JOINT REGIONAL PLANNING PANEL (Sydney West)

JRPP No	2015SYW213
DA Number	913/2016/JP
Local Government Area	THE HILLS SHIRE COUNCIL
Proposed Development	RESIDENTIAL FLAT BUILDING DEVELOPMENT
Street Address	LOTS 101 – 103 DP 1195876, NO. 2B AND LOT 103 HECTOR COURT AND LOT 102 AFFLECK CIRCUIT, KELLYVILLE
Applicant	DAVID KREPP
Number of Submissions	First Notification: 34 submissions and a petition signed by an additional 30 persons. Second Notification: Nine
Regional Development Criteria (Schedule 4A of the Act)	CIV EXCEEDING \$20 MILLION
List of All Relevant s79C(1)(a) Matters	• LEP 2012 • DCP Part B Section 5 – Residential Flat Buildings • DCP Part D Section 7 – Balmoral Road release Area • SEPP 65 - Design Quality of Residential Flat Development • SEPP 32 – Urban Consolidation of Land • SEPP (State and Regional Development) 2011 • SEPP Building Sustainability Index BASIX 2004 • SEPP 55 - Remediation of Land • SREP 20 – Hawkesbury Nepean River

EXECUTIVE SUMMARY

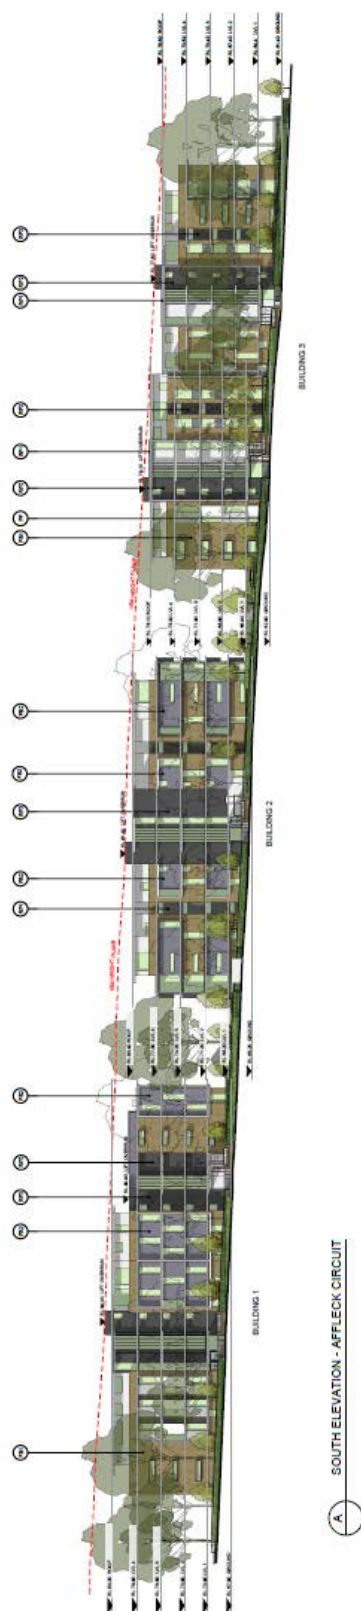
LEP 2012 limits the height for the site to 16 metres. The proposed height is a maximum 16.4 metres to the top of the lift. This represents a maximum 2.5% variation to the LEP standard. Attachment 6 shows the LEP height limit in relation to the buildings.

The proposed variation to the building height is not considered to be an architectural design feature and as such a Clause 4.6 variation is required. The proposal is considered to be unsatisfactory and cannot be determined in a positive manner given the non-provision of the Clause 4.6 variation request.

The proposed lift over-runs are a clear feature of the roof line. The lift over-runs do not add to the architectural design of the roof and do not result in a high quality built form. As such the proposal is considered to be unsatisfactory in regard to the objective of the clause.
